Safety Evaluation Report

NUREG-75/080

related to construction of
**Wolf Creek Generating
Station, Unit No. 1**

Docket No. STN 50-482

FIGURE 17.1 SNUPPS PROJECT ORGANIZATION

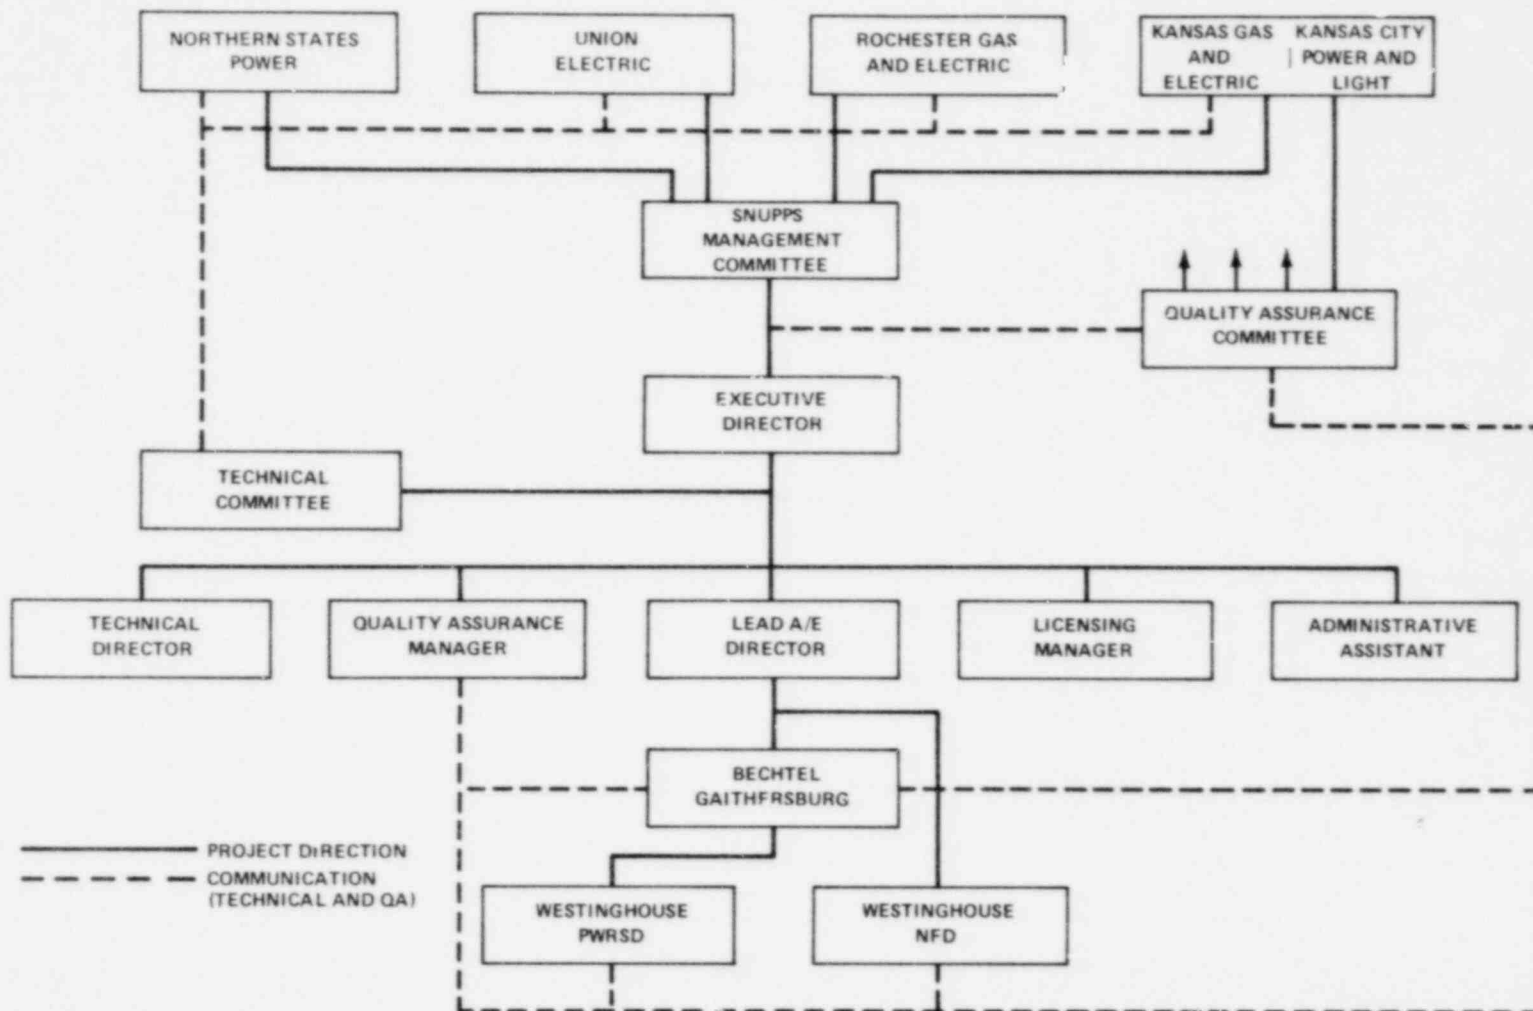
The SNUPPS Project Organization is administered by a Management Committee established by the SNUPPS utilities and is managed by an Executive Director who acts for the SNUPPS utilities. The project direction and organization are shown in Figure 17.1.

The SNUPPS QA Committee shown in Figure 17.1 consists of one QA representative from each SNUPPS utility. The functions of the QA Committee are to develop the QA manual of procedures, to review and approve Bechtel and Westinghouse QA Programs and to verify their adequacy for the project, to provide formal audits of the SNUPPS Project Organization, and to evaluate the effectiveness of the QA Program implementation for the Management Committee. Each member of the QA Committee is under administrative control by his respective utility.

The Executive Director is responsible to the Management Committee for the review and direction of the Bechtel activities. He also coordinates the interface requirements between each SNUPPS utility, Bechtel, and Westinghouse. He is responsible for the implementation of the QA Program through the QA Manager.

Figure 17.4 KANSAS GAS & ELECTRIC COMPANY ORGANIZATION

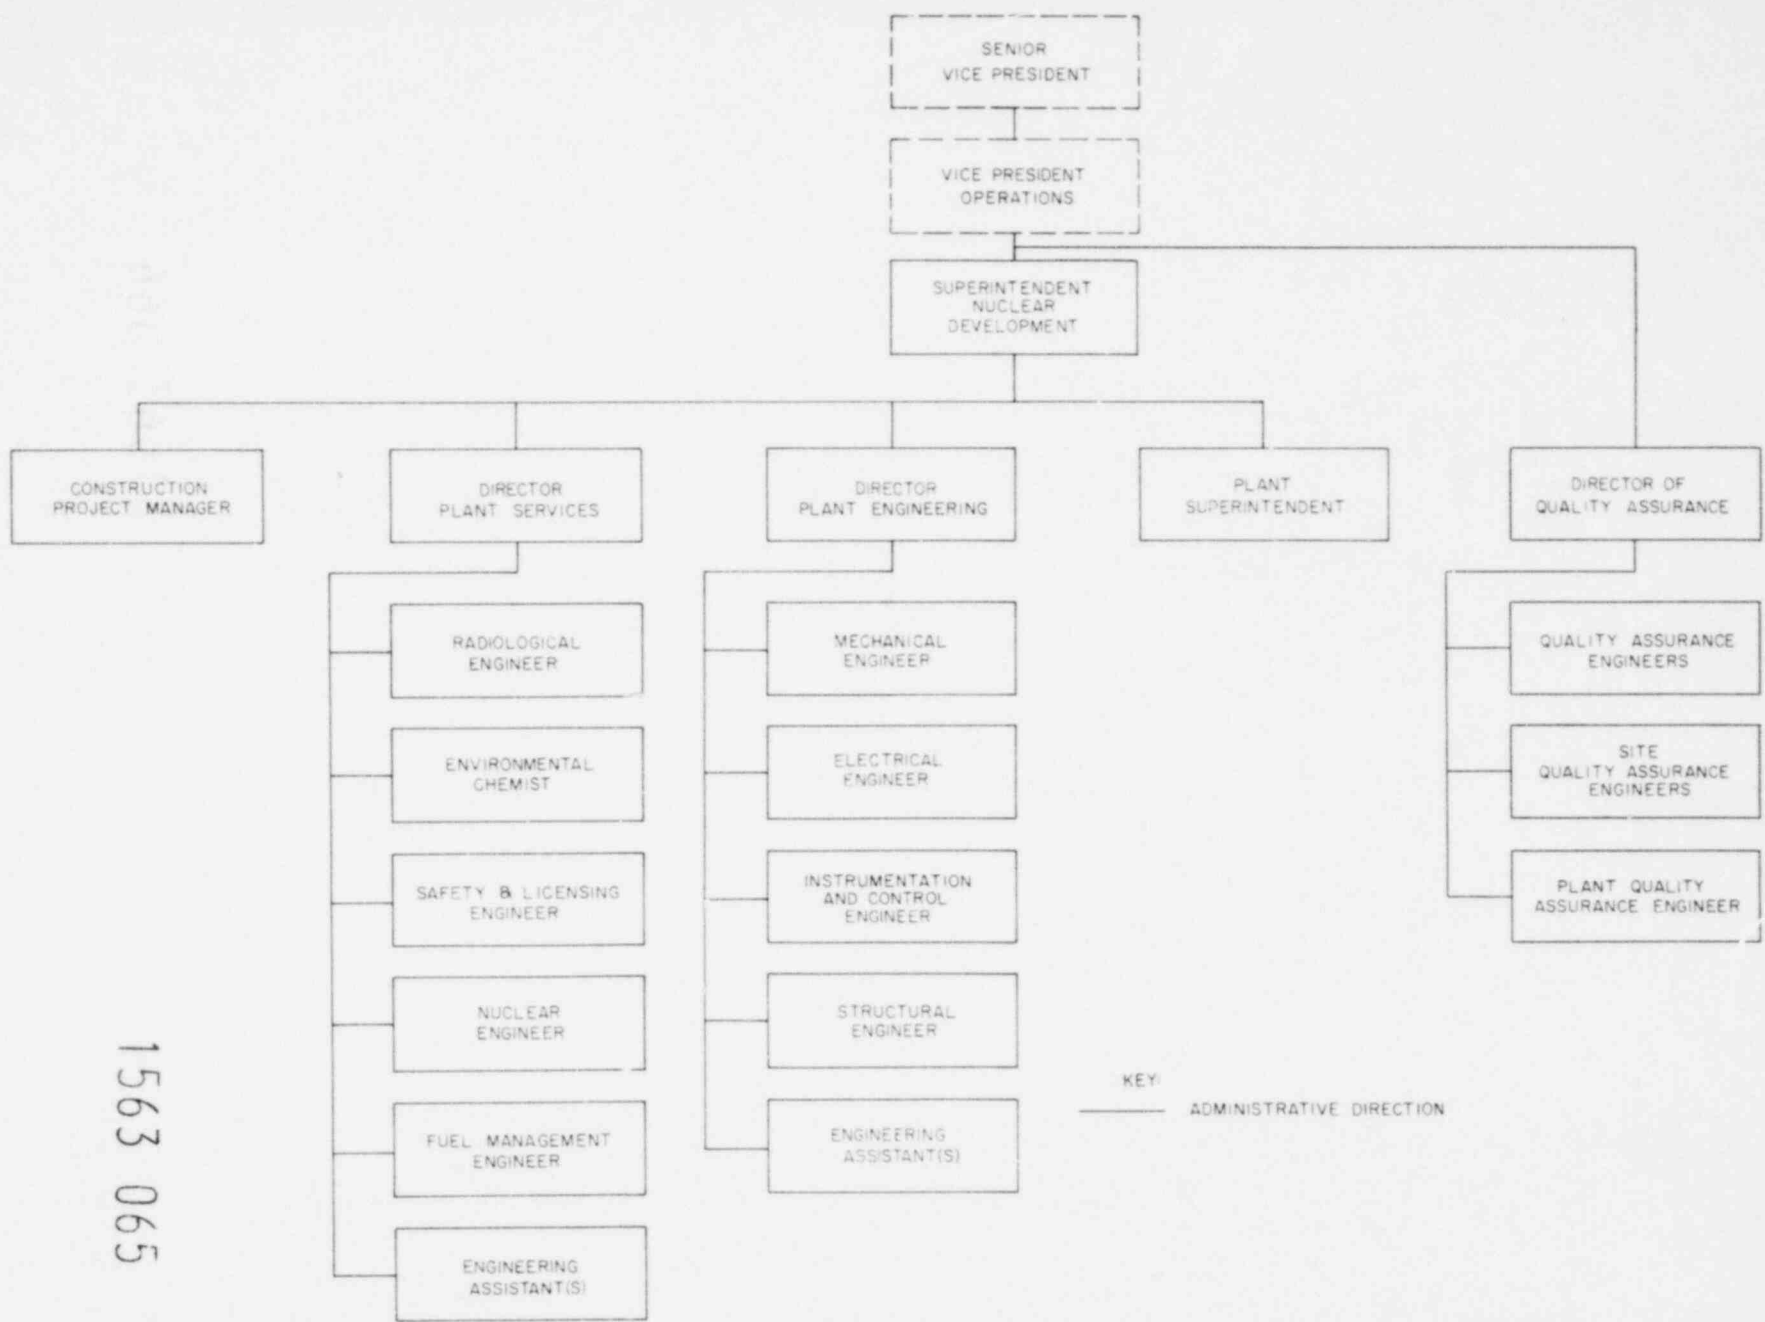
Figure 17.4 shows the Director of Quality Assurance on the same organizational level as other directors in the Nuclear Development Department whose QA activities he verifies. The Director of Quality Assurance has well defined responsibilities and authorities for implementing the QA Program with documented procedures and instructions. Based on our review of the Kansas Gas & Electric Company's organization and associated responsibilities, we find that QA has adequate independence and reports at a sufficiently high management level to accomplish its objectives.

Based on our evaluation of the Kansas Gas & Electric Company's QA organization, we find that it is sufficiently independent of the organizations whose work it verifies; it has clearly defined authorities and responsibilities; it has adequately defined qualification and training requirements for its staff; it is so organized that it can identify QA problems in the other organizations performing QA related work; it can initiate, recommend or provide solutions; and it can verify implementation of

FIGURE 17.5 DANIEL INTERNATIONAL CORPORATION ORGANIZATION

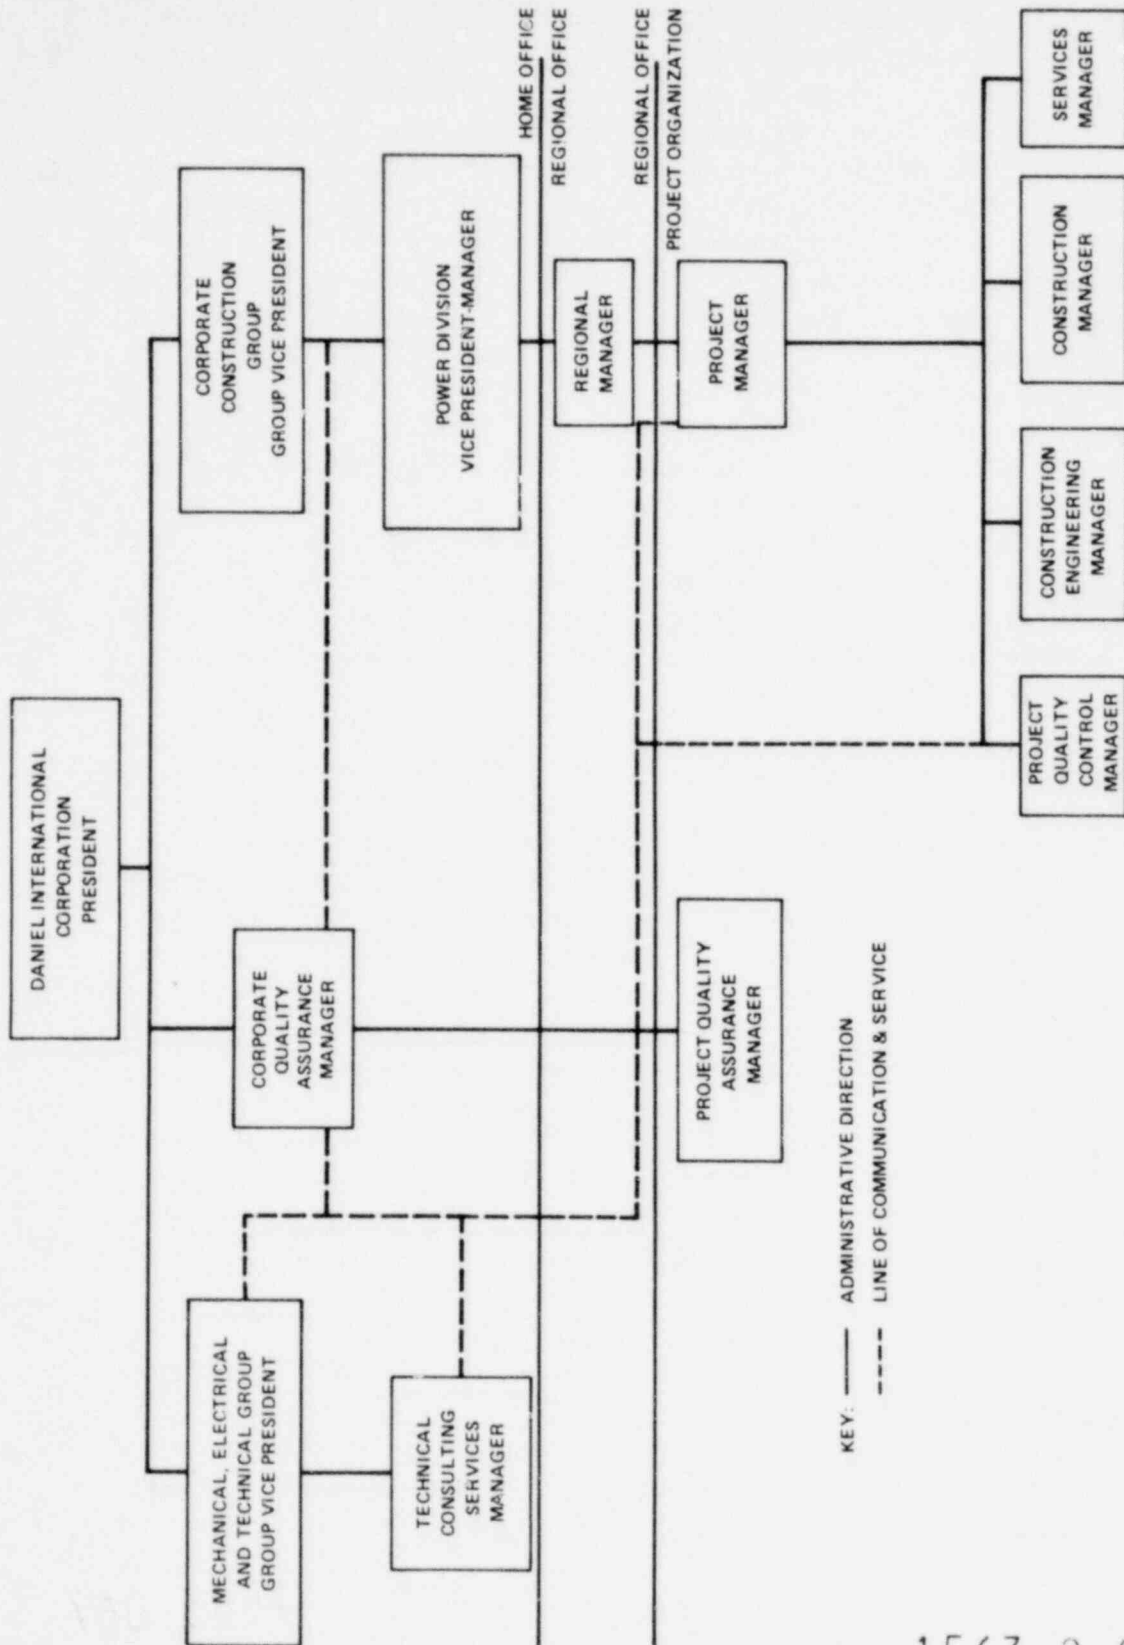
Daniel, as the construction contractor, will control and implement the Quality Control program required during the construction of the Wolf Creek plant. Activities include bulk procurement, receiving of materials and items from Bechtel, and onsite fabricating, erecting, manufacturing, inspecting, cleaning, and testing. The Daniel organization for Wolf Creek is shown in Figure 17.5.

The Power Division is assigned responsibility for construction. A Project Manager, reporting to the Power Division, is assigned responsibility for construction of the Wolf Creek plant. The Quality Control Manager, reporting to the Project Manager, is responsible to provide the inspection services, documentation, and control of construction activities and has stop work authority to control unsatisfactory performance.
